Service Letter

20-87
DATE: 12-20-61

SUBJECT: Repair for Cracks in Nose Gear Leg, P/N 5074

MODELS AFFECTED: M20, M20A & M20B, Serial Numbers 1002 thru 1884

FIG. 1 -- TOP VIEW OF 5164 AND 5074-9A & -10

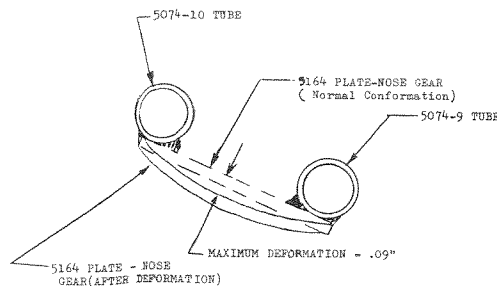
1. Inspect the nose gear leg in the area of the P/N 5164 plate at the top of the shock stack. Cracks have been found in the welds between this plate and the two horizontal tubes (5074-9 and -10).

- b. If the crack is 3/8 inch or less in length, Vee the crack out on a 1/8" radius minimum and add the 1.00" welds on the inside of the tubes at the four corners as shown in Figure 1. Do not add any weld to fill up the Vee where the crack had existed.

1 Inspect for cracks in the weld at the four corners of 5164.

2 Add these welds if necessary to meet the requirements of this service letter.
